Access Compliance Report

Public Rights-of-Way

Intersection ID: 49284	Main Street: PRESERVE_PL	Cross Street: MEADOWBROOK_RD	Location: NW
ADA ID: E8A9E8FB56CB	Ramp Type: PerpDiag	Initial Pass/Fail: Pass	Overall Compliance: No
		Severity Score: 0.25

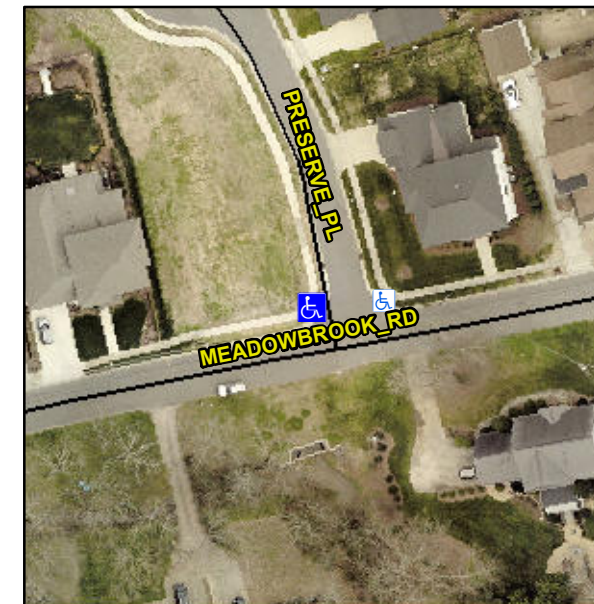
Possible Solutions:

Remove & Replace Curb Ramp With Two New Directional Ramps or Equivalent. Remove & Replace Gutter.

PROW/ADA:

R304.5.3, R304.2.1
